**Notice of Intention  
To Commence Large Mining Operations**

**US Oil Sands (Utah) Inc.  
PR Spring Mine  
M0470090**

May 2009

**FIGURE 2**  
 MINE SURFACE FACILITIES  
 AND LAND STATUS MAP

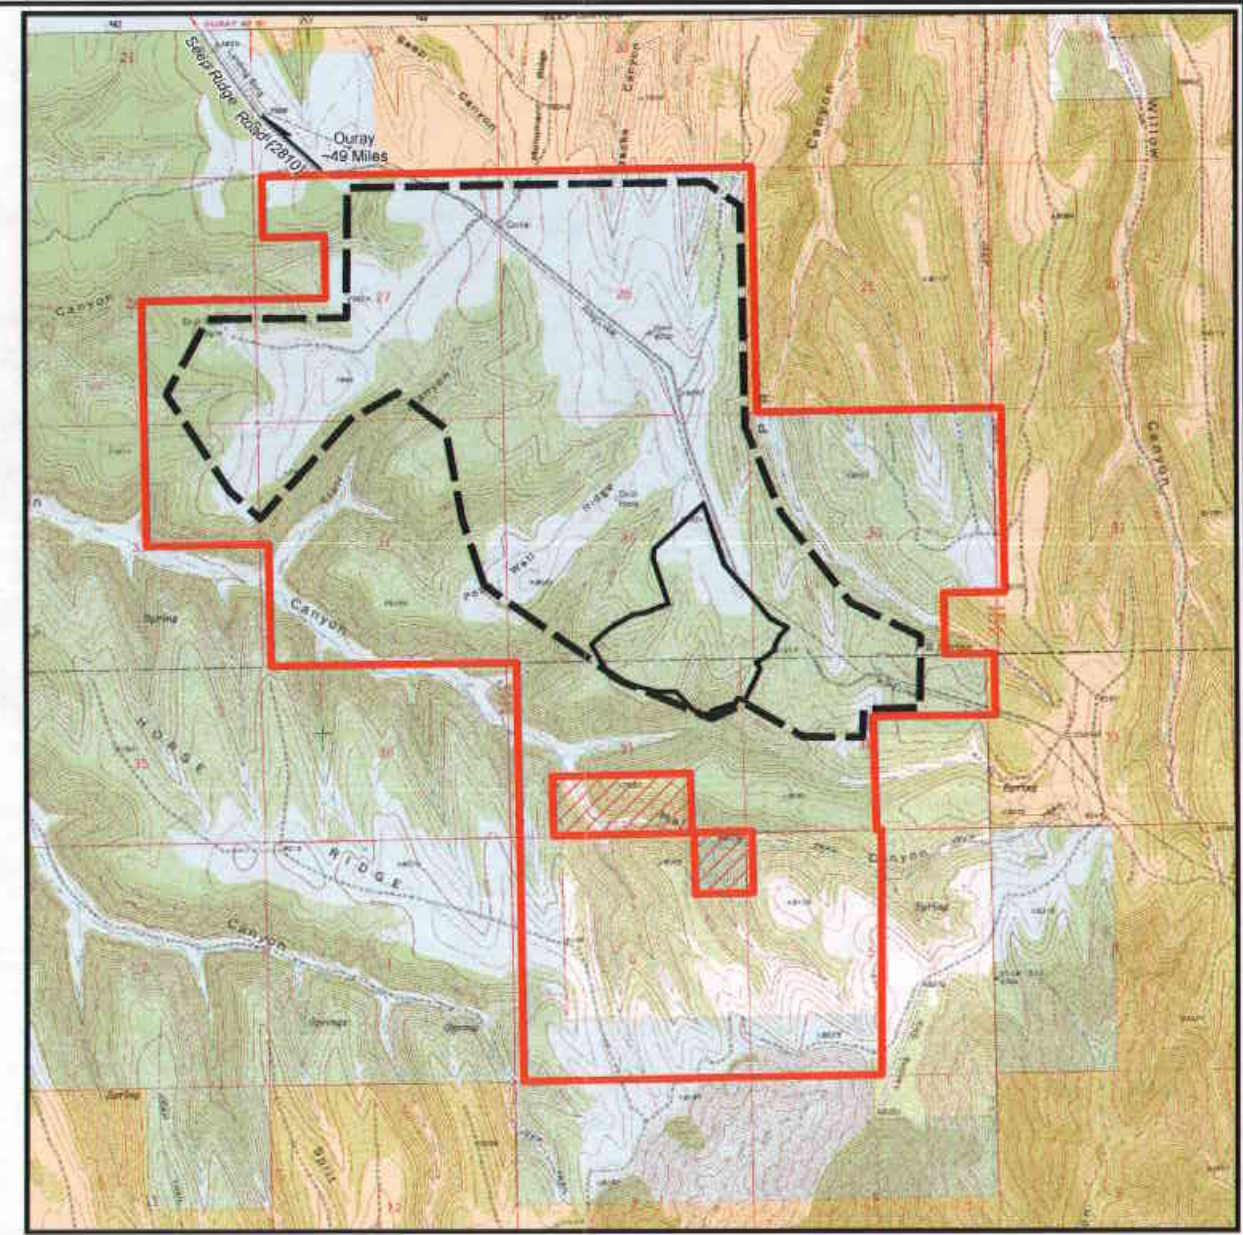
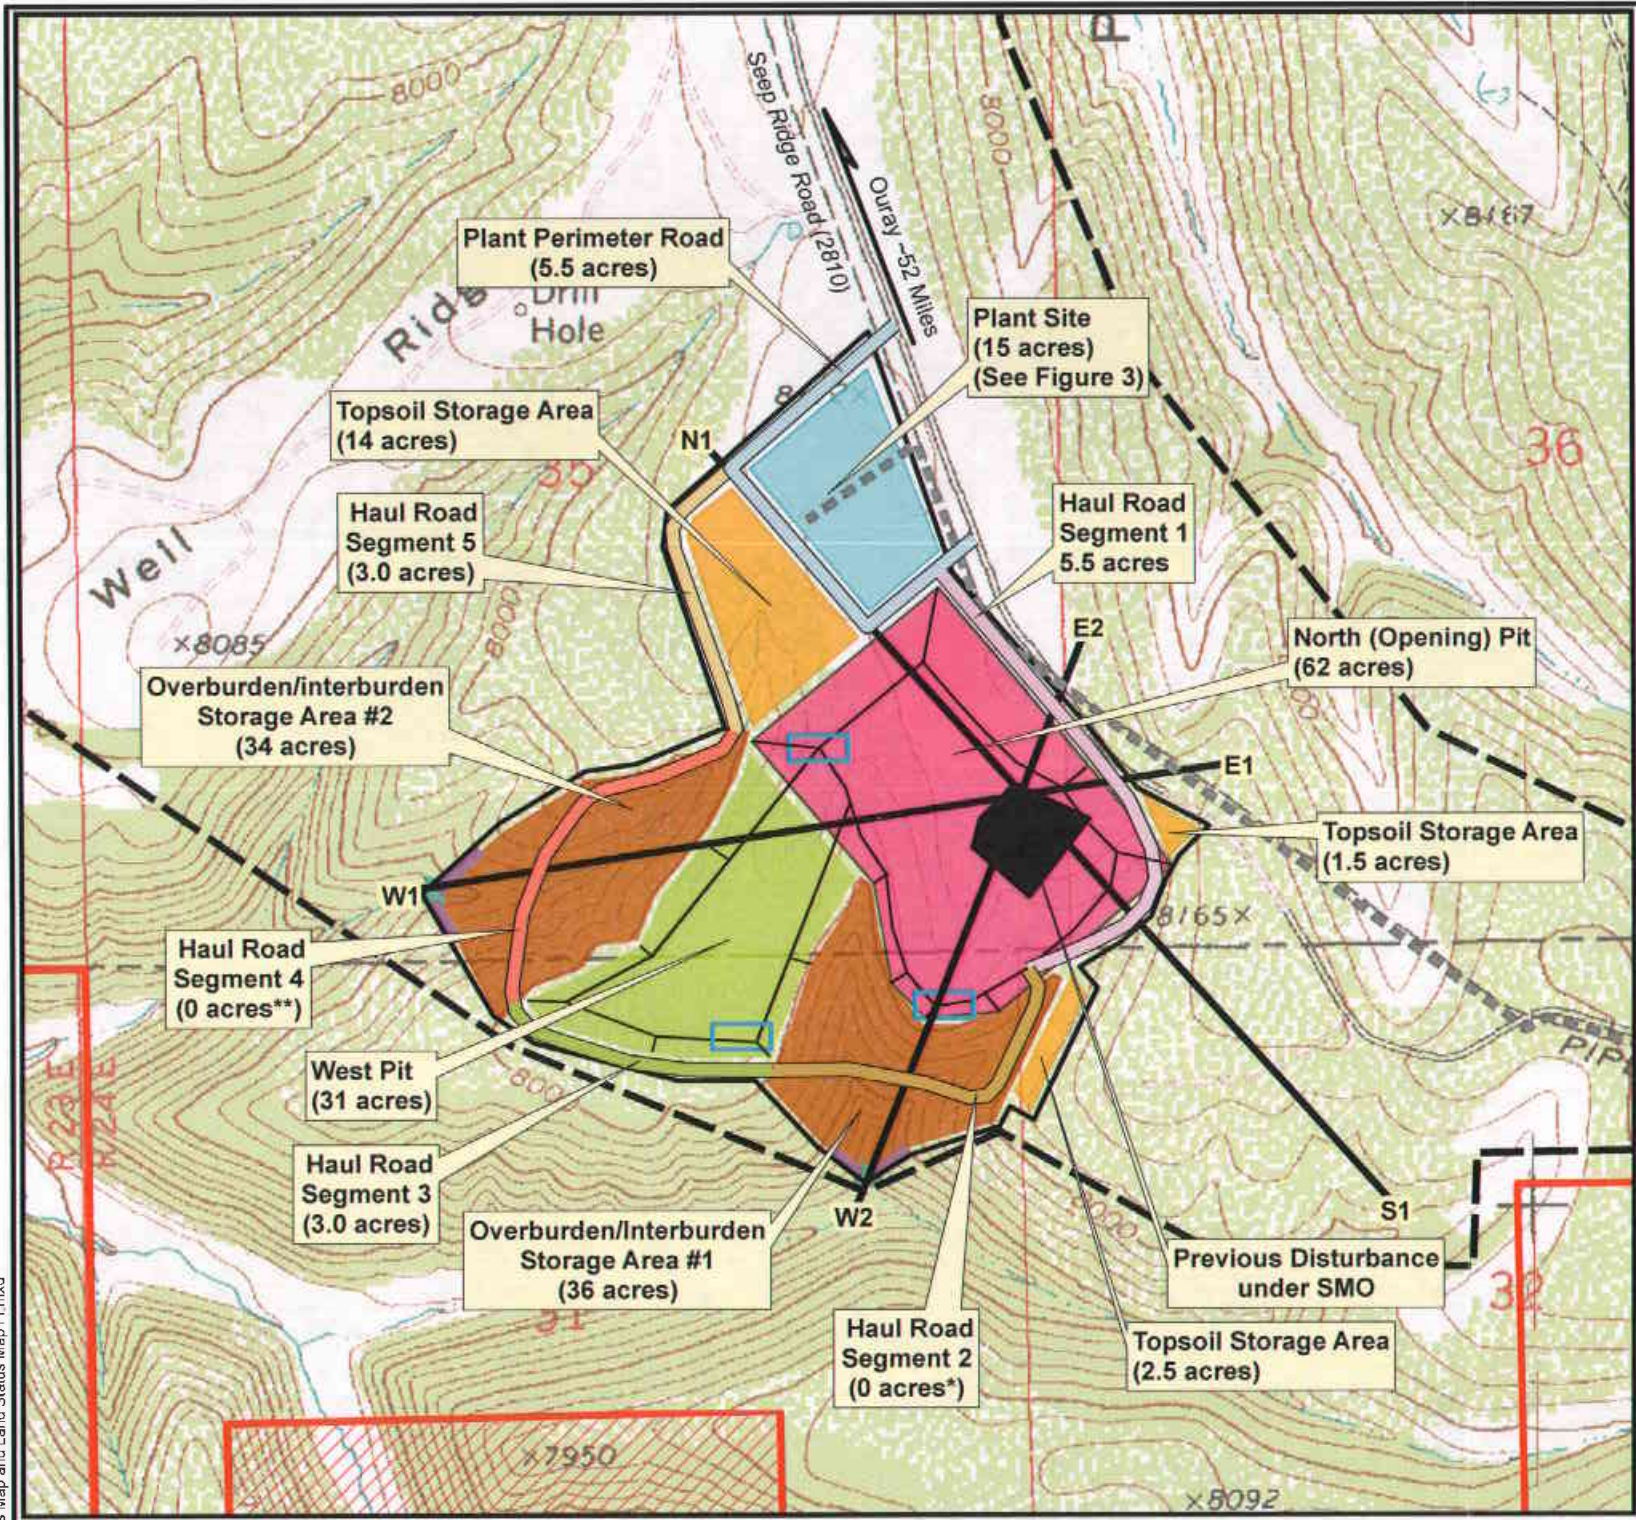
Comment #	Sheet/Page #	Comments	Review Action	Earth Energy Responses
8	Conf - Figure 2	Rip-rap armored channel – As shown channels will be difficult to build without disturbance outside the “affected area”. (lah)	A	Rock rubble riprap will be placed in erosion prone drainage channels with as little disturbance to adjacent land as possible. All disturbance will however be contained within the perimeter of the disturbance boundary. Should construction of erosion controls be required outside the present limits of the disturbed area boundary, Earth Energy will seek an amendment to the NOI.
9	Conf - Figure 3	Great figure to tie to the bond calc sheet. (lah)	A	As discussed during the meeting of January 14, 2009, the description of facilities in Figure 3 matches the descriptions used in the bond calculation sheet. We feel that additional revisions to Figure 3 to attempt to tie the Figure to the bond calculation sheet will not be informative or helpful.

Comment #	Sheet/Page #	Comments	Review Action	Earth Energy Responses
7	Figure 2	The word proposed mine operations shows several colors of hatching, however none of them are identified using a key. There is no indication of what they mean. Please correct. (BE)	A	This comment was carried over from the Division's Initial Review. In response to the comment, the figure was removed from the May 9, 2008 2 <sup>nd</sup> draft NOI and information was presented in other figures. Thus, the comment is irrelevant to the current version of the NOI, and no further response is needed.
8	Figure 2a	Include either plan view of feature or more description of where feature will be used. Nothing has been included catch basins, sediment ponds, etc (lah)	B	These features will be used at locations shown on Figure 2. They will function as sediment traps/energy dissipation at the toe of the overburden/interburden storage areas. By design and by nature, these areas are not expected to generate large quantities of sediment or runoff: they will not collect up-gradient runoff, they are constructed at moderate gradient, and their substrate is coarse and porous. Therefore, large sediment ponds are not needed to control either runoff or sediment from these overburden/interburden storage areas. See the text in Section 109.4 of the May 9, 2008 2 <sup>nd</sup> draft of the NOI, and the current version of the NOI for additional discussion of this issue. Further, as was indicated in numerous locations in the May 9, 2008 2 <sup>nd</sup> draft of the NOI, a water retention/sediment pond is planned to prevent sediments from moving off the plant site; that pond was shown on Figure 3. Please refer to responses detailed in sections 42, 43, 55 & 58 that follow below.

The 2255.15-acre area that was labeled as NOI Permit Area in Figure 2 of the September 28, 2007 NOI has been relabeled as "Study Area" to reflect that this area was the subject area for resource descriptions. This change was also made to all other figures that included this boundary.

Figures 2 and 3 have been combined into a single Figure 2 to provide consistency and to reduce the DOGM confusion.

Figure 2 has been modified to include the southern portion of the lease boundary. It is now all-encompassing, showing all boundaries.

Pit contours have been added to Figure 2. The designed pit perimeter wall is simply meant to reflect the cut nature of the pit which results in the pit being an impounding structure during operations, as described in the NOI.

FIGURE 2a  
 GENERAL ARRANGEMENT OF OVERBURDEN  
 STORAGE AREA AND SAND TAILINGS  
 ENCAPSULATION CELLS

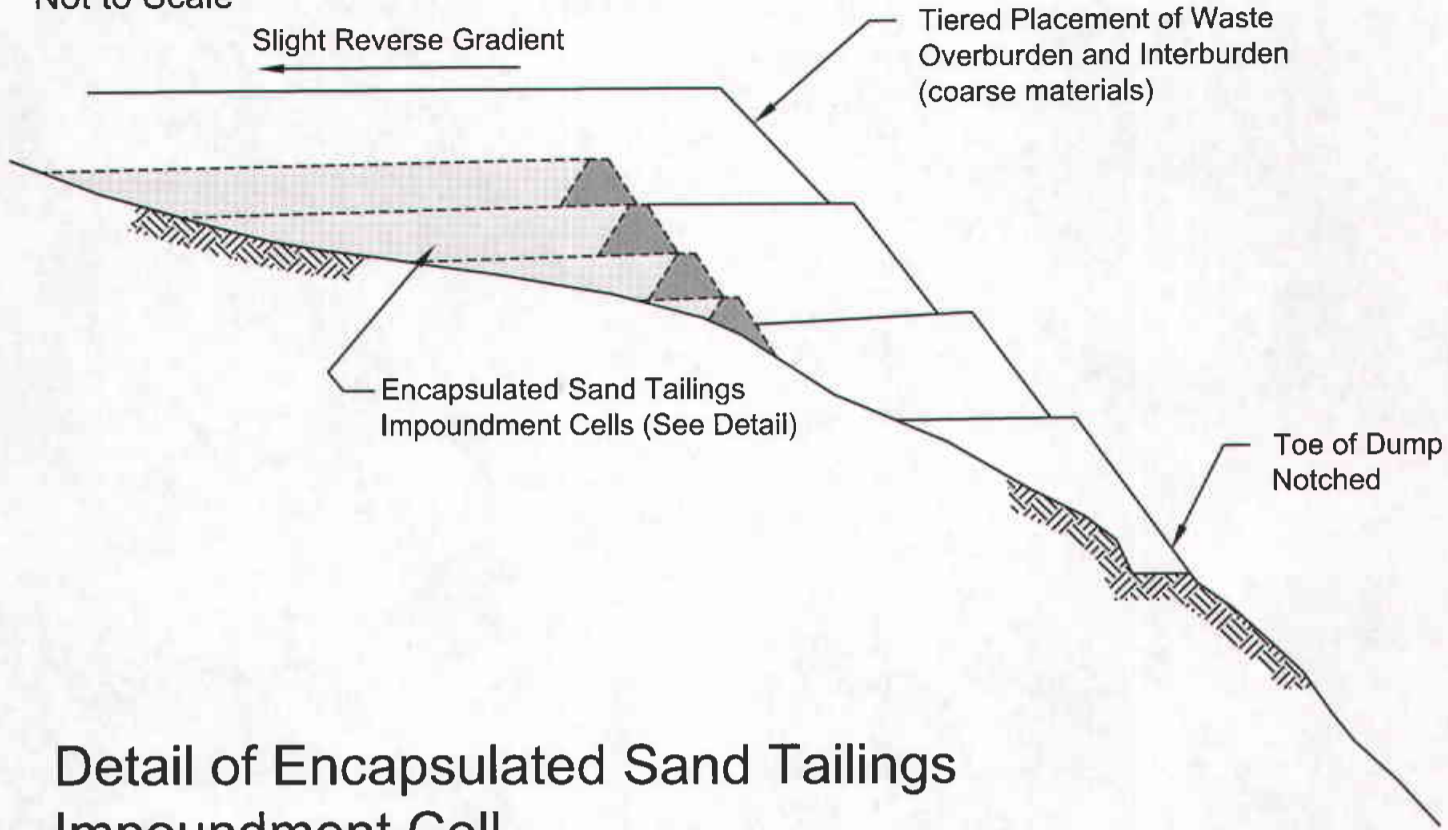
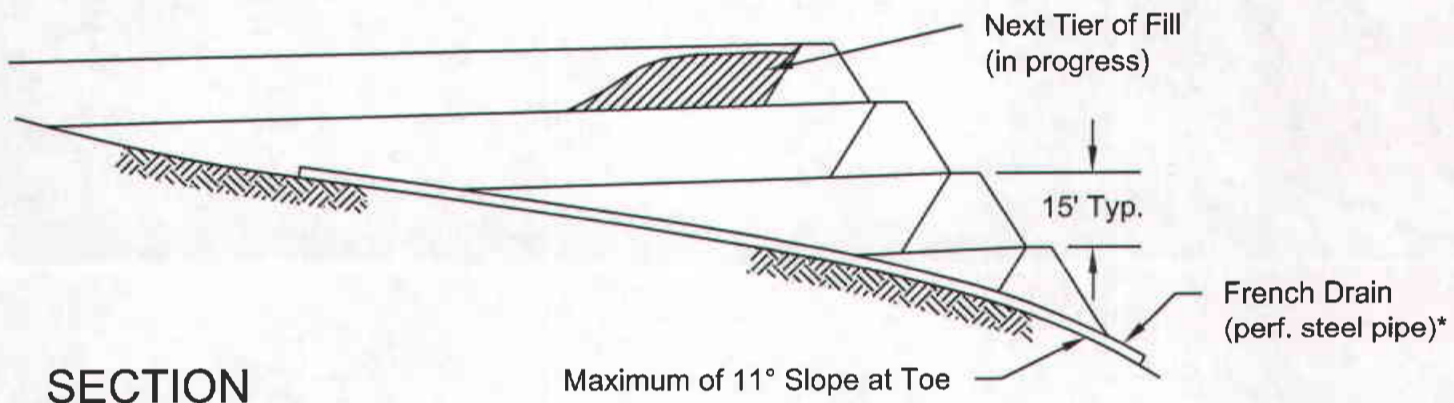
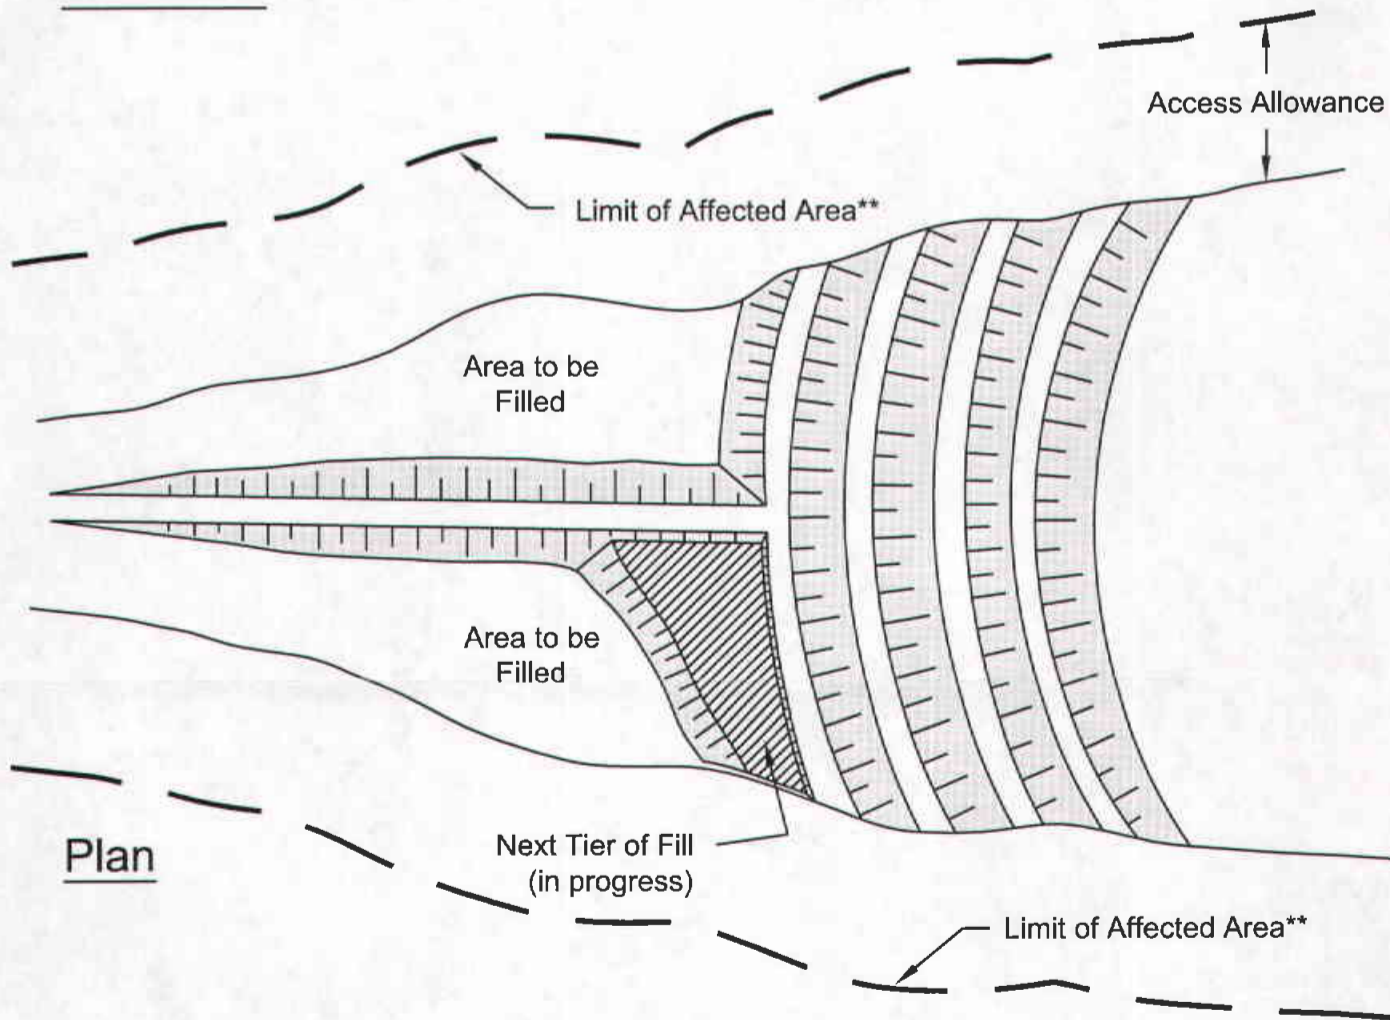
Comment #	Sheet/Page/Map/Table #	Comments	Initials	Review Action
	Figure 2a / Page 20	Figure 2a and paragraph 4 say the containment "cells will not be constructed on slopes greater than 20 percent (11 degrees)" yet Figure 2a notes "maximum of 20 degrees slope at the toe." Please correct or clarify the text or figure to reflect slope stability model that used for mine planning from the engineer of record.	lah	Figure 2a has been corrected.
	General	It is DOGM's recommendation that slope designations (percent, degrees or horizontal:vertical) are consistent throughout the document.	lah	Thank you for the recommendation. No change has been made to the plan at this time.
	Figure 2a	Upper drawing, berm should not be shown as the same material as the sand tailings.	lah	Figure 2a has been revised.

9	Figure 2a	Overburden should be keyed into natural slope for stability FOS (lah)	B	Earth Energy mine engineers do not feel that it is necessary to key overburden in to the slopes in all locations or as a matter of general design. However, on the steepest areas of overburden placement, the toes of fills may be keyed into existing slopes as deemed necessary in the field at time of placement; a statement to this effect has been added to the NOI, but figure changes have not been made. Also see the response to Comment #51, which discusses the conservative nature of the overburden/interburden storage area design.
10	Figure 2b	Include either plan view of feature or more description of where feature will be used. Where will a unlined ditch be used as opposed to a rip rap lined ditch, where will the berm be used in the plan (lah)	B	Earth Energy does not believe that a plan view of a typical berm or a typical ditch is needed; the cross sections provided in Figure 2b are fully understandable and these features are common, typical, and standard. Cross sections are a standard way to describe such structures. In regard to exactly where they will be used, and additional descriptions, please see changes that have been made to pages 16 in Section 106.2 in the current version of the NOI.

FIGURE 2b  
OVERBURDEN/INTERBURDEN STORAGE AREAS  
RUNOFF AND EROSION CONTROL STRUCTURES

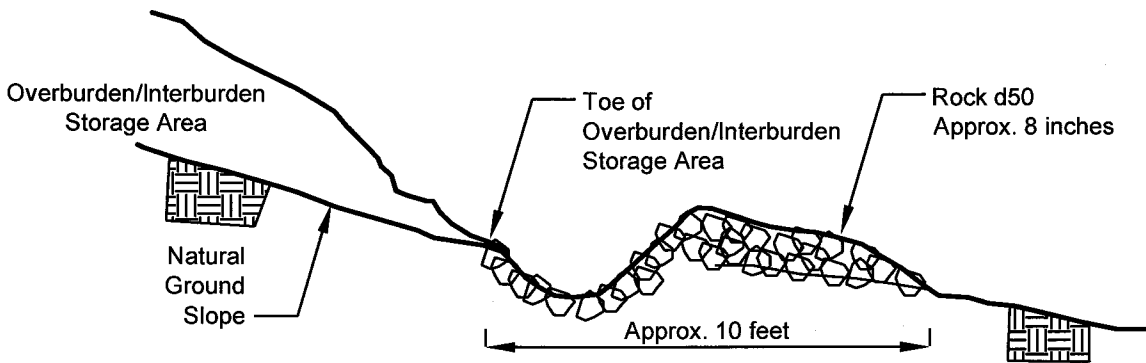
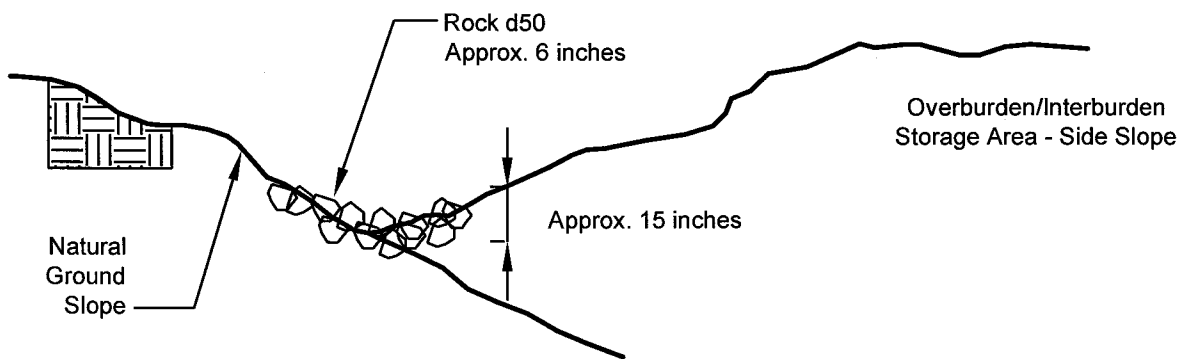
10	Figure 2b	Include either plan view of feature or more description of where feature will be used. Where will a unlined ditch be used as opposed to a rip rap lined ditch, where will the berm be used in the plan (lah)	
11	Figure 3	Define 203 acres listed in text and in bonded area. (lah)	
12	Figure 3	Label figure 3 - features to be tied to surety bond (lah)	
13	Figure 3	The facilities map should include the dimensions of the buildings, ponds, piles etc. These dimensions can be part of the legend and referenced appropriately. The map should show roads, including access and haul roads; utilities and power lines (water, gas, power, telecommunications etc); and drainage control devices. (BE) Maximum size of the facilities are needed for bonding calculation purposes. (lah)	
14	Figure 4a,4b,4c,6	FYI only, best if drawn with no vertical exaggeration, best if all x-sections are the same scale, engineering standards for drawing are lacking (lah)
